PUBLIC UTILITIES COMMISSION

October 6, 2014

RE: Request for Additional Data #2 – Certificate of Public Convenience and Necessity for the Sycamore-Peñasquitos 230-Kilovolt Transmission Line Project – Application No. A. 14-04-011

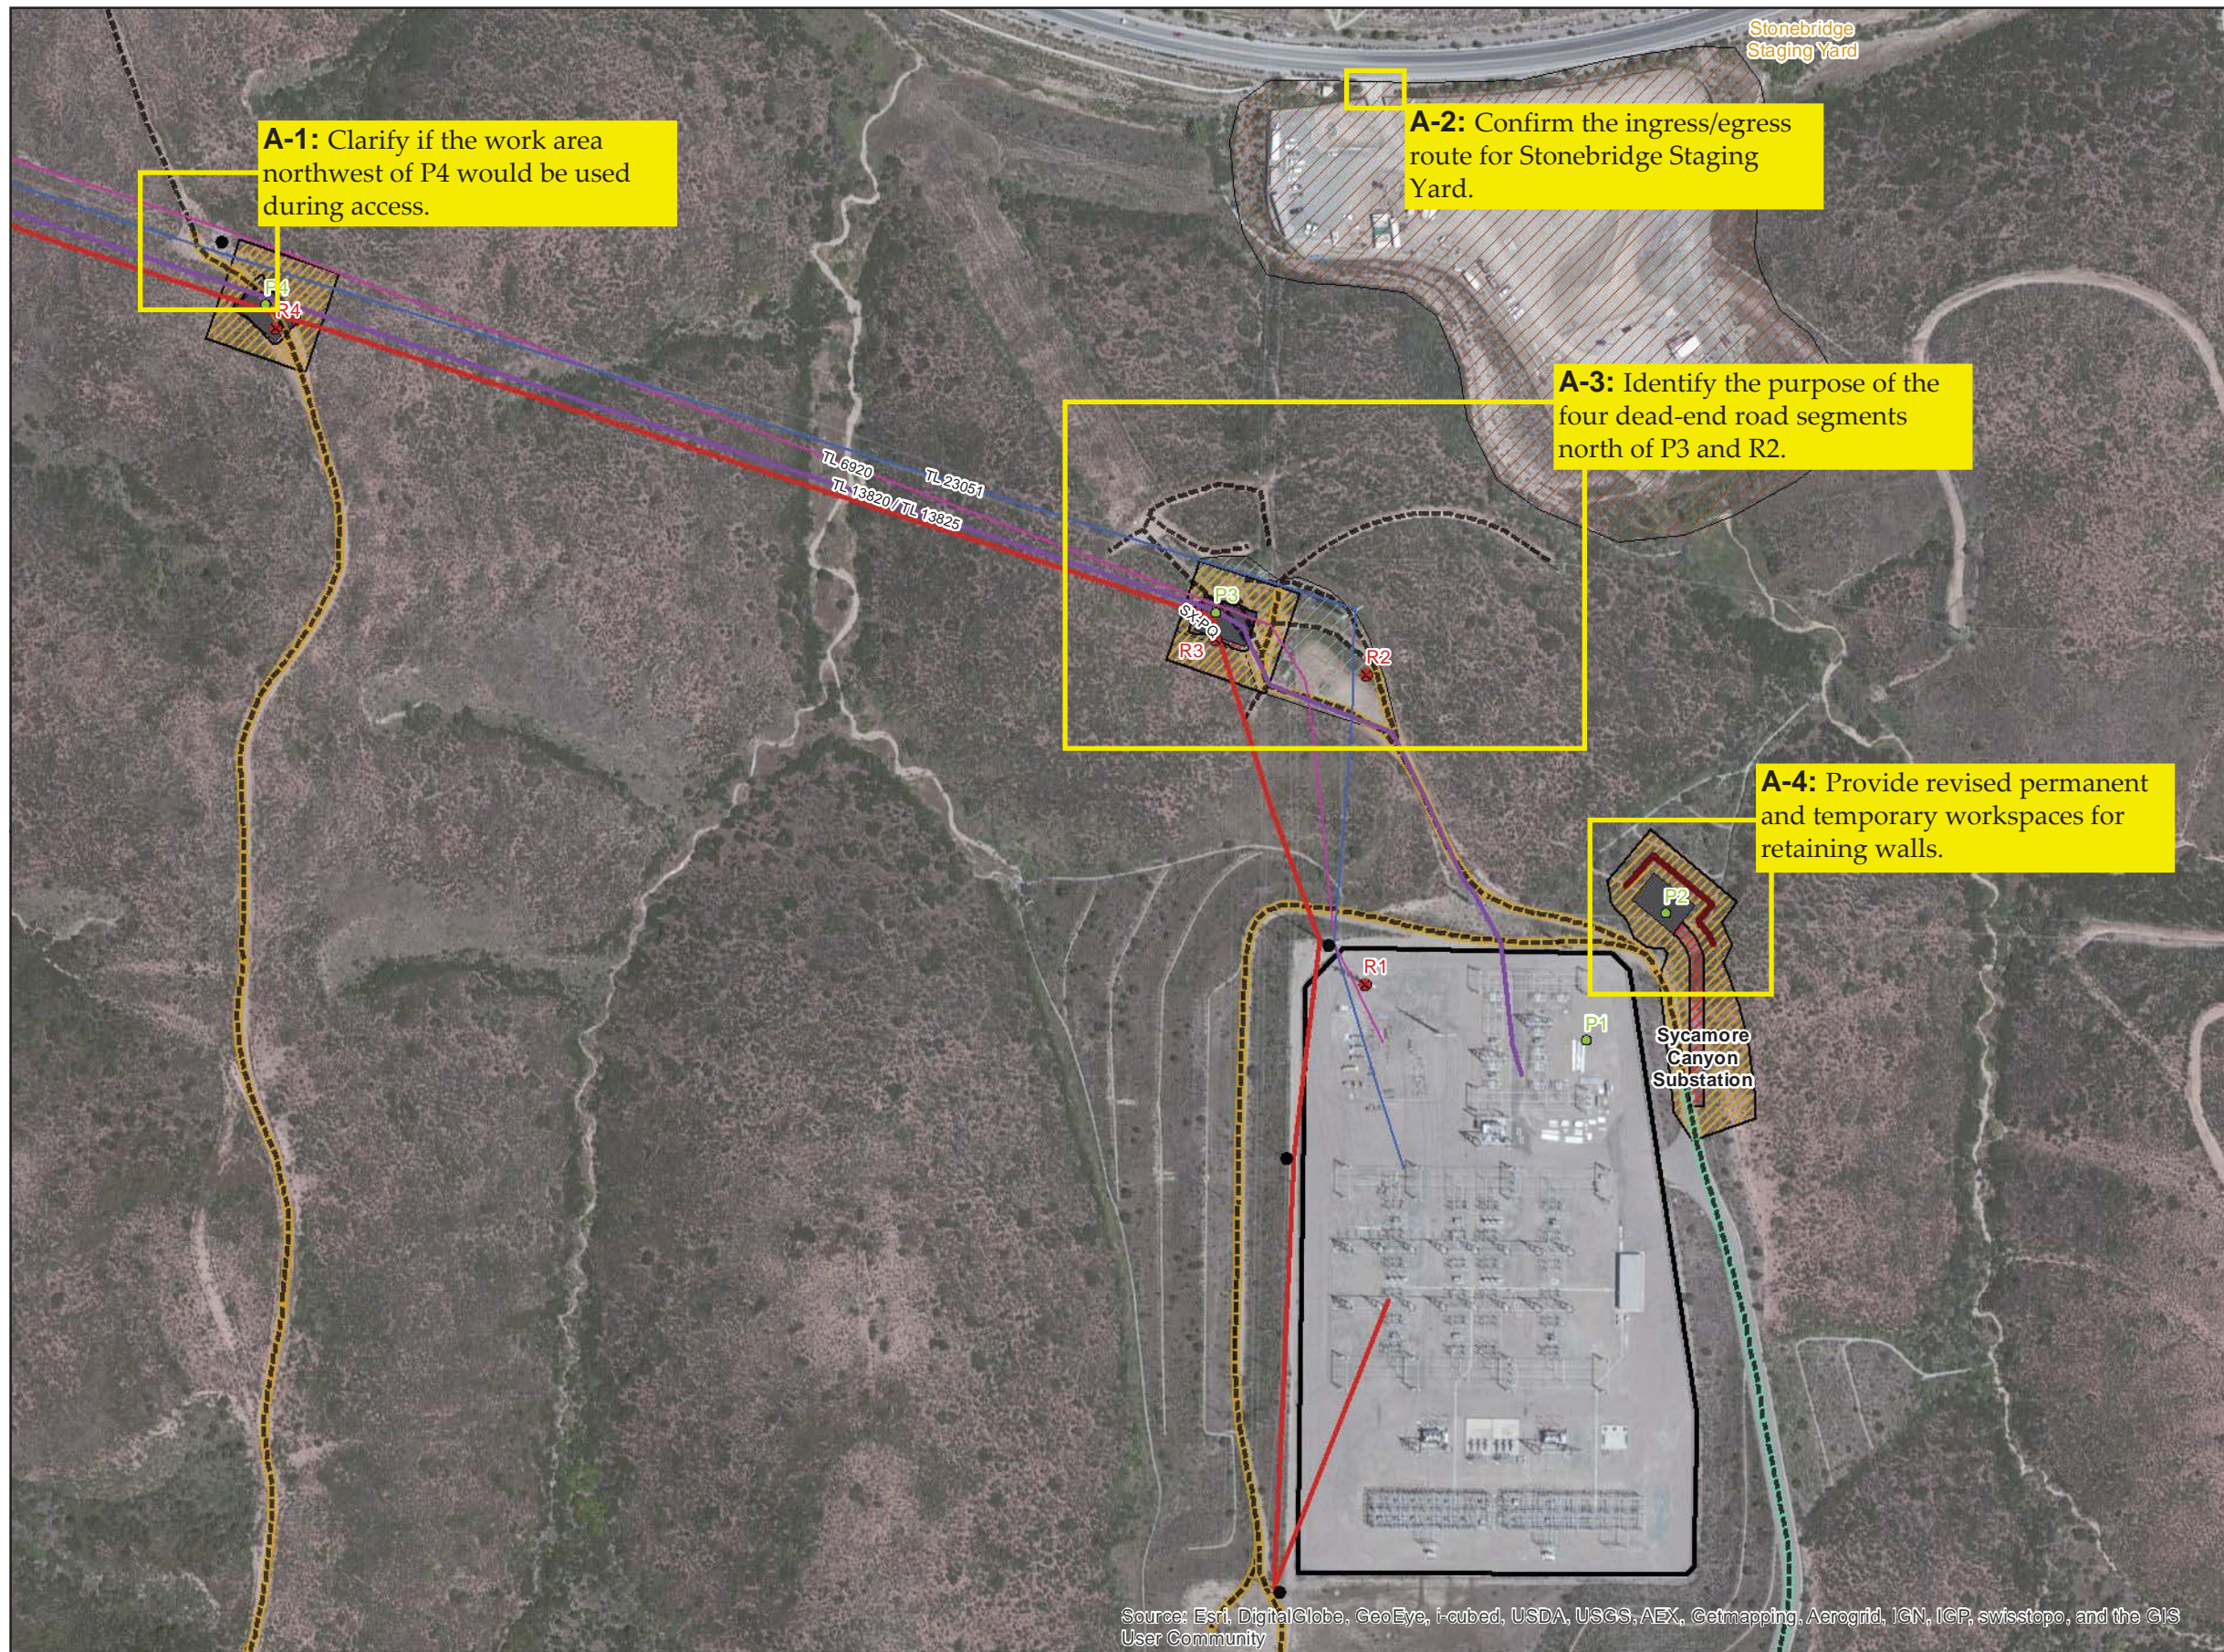
A-5: Confirm that GS4 has been removed.

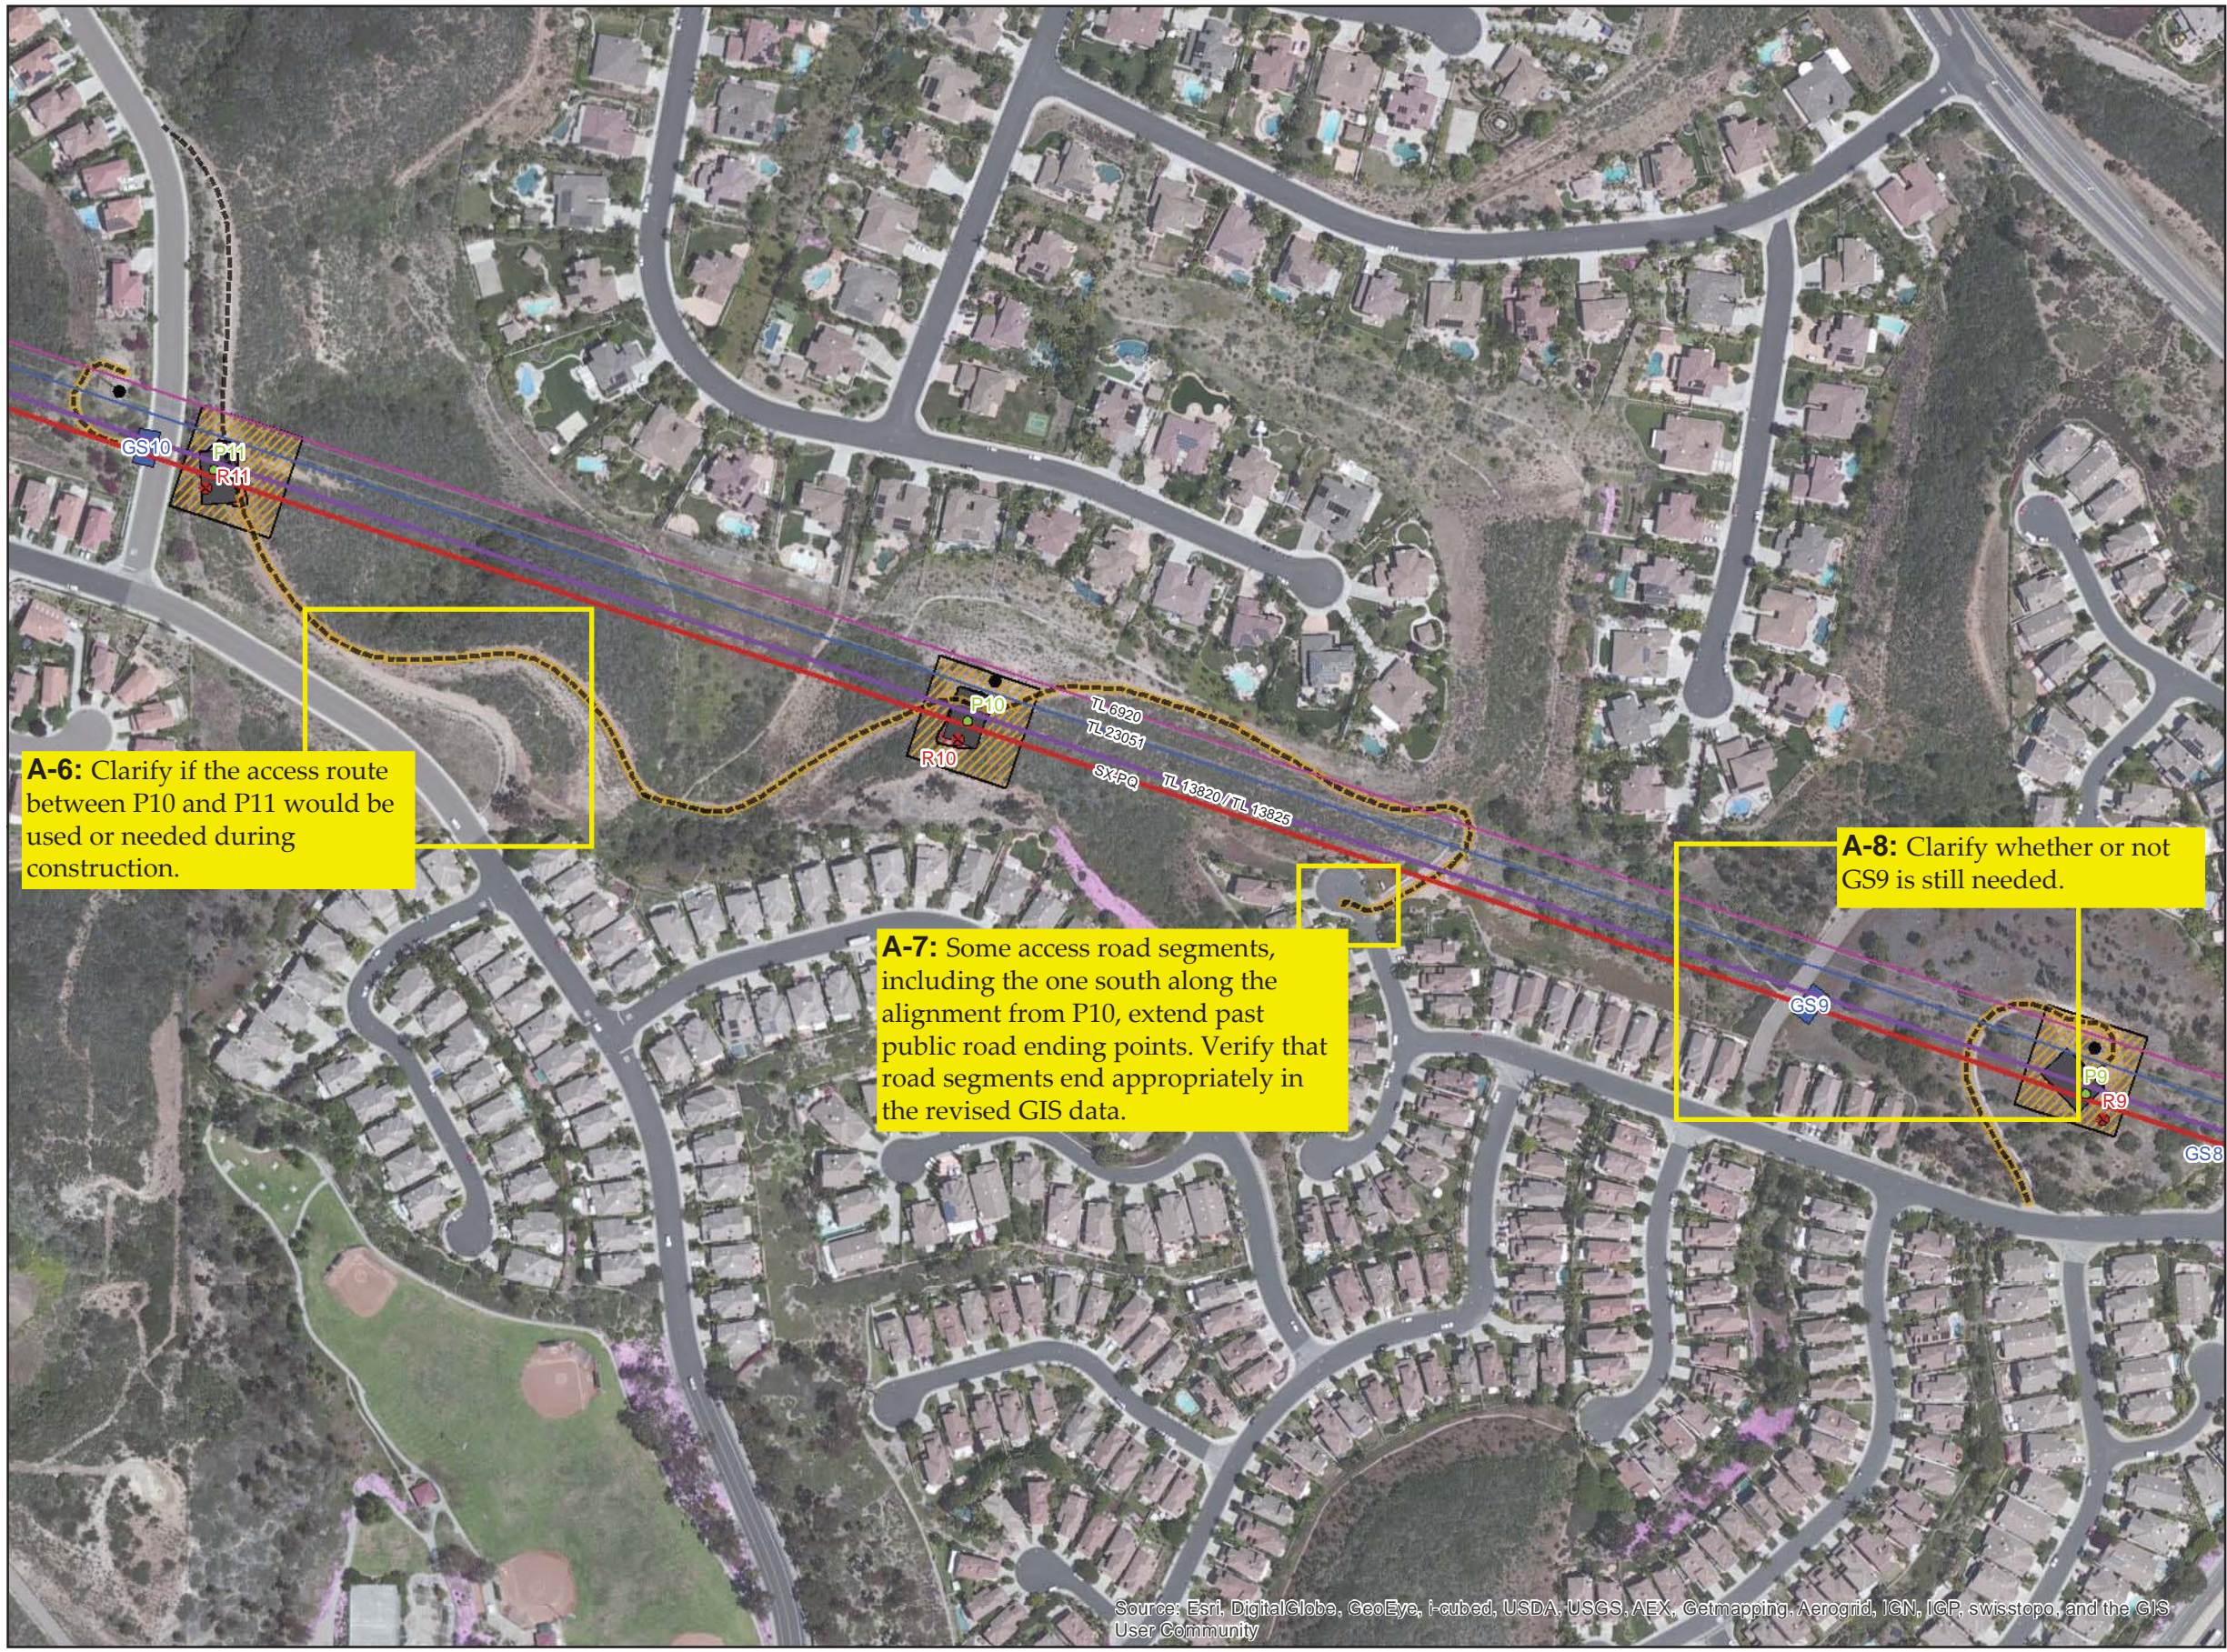
A-8: Clarify whether or not GS9 is still needed.

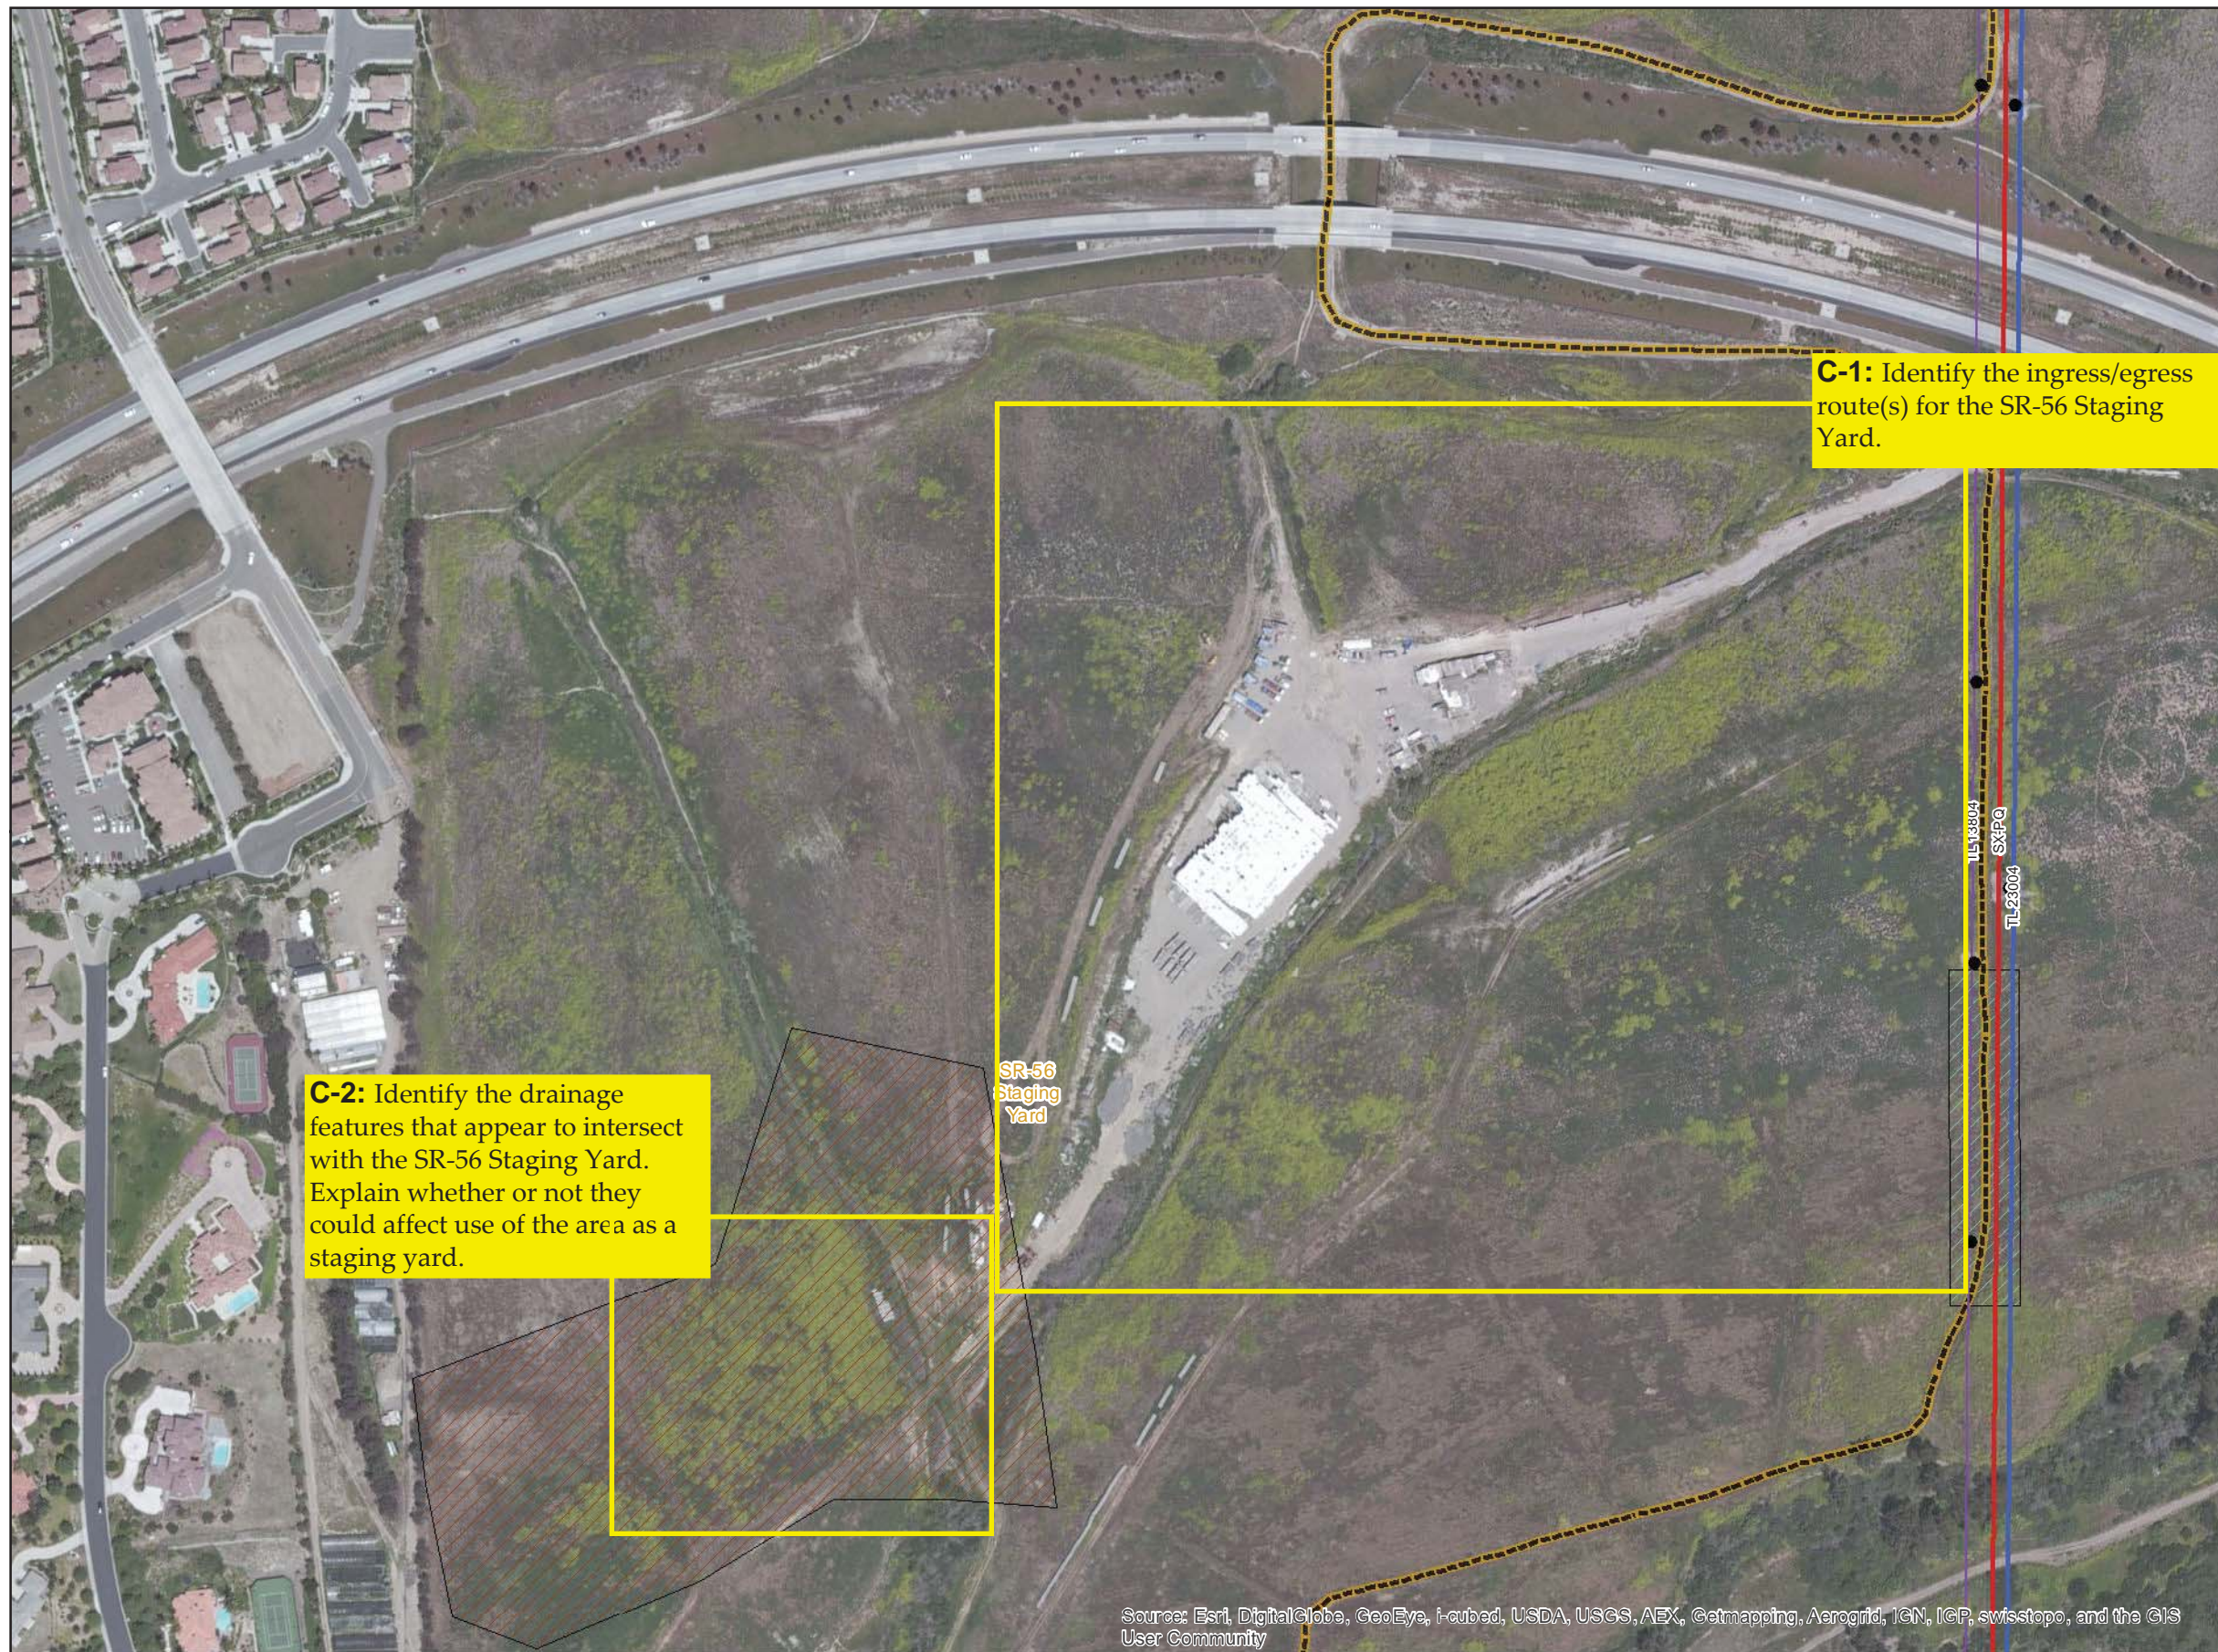
C-6: Remove the additional road segment at the end of the access route that leads into the western cul-de-sac of Santa Fe Canyon Place.
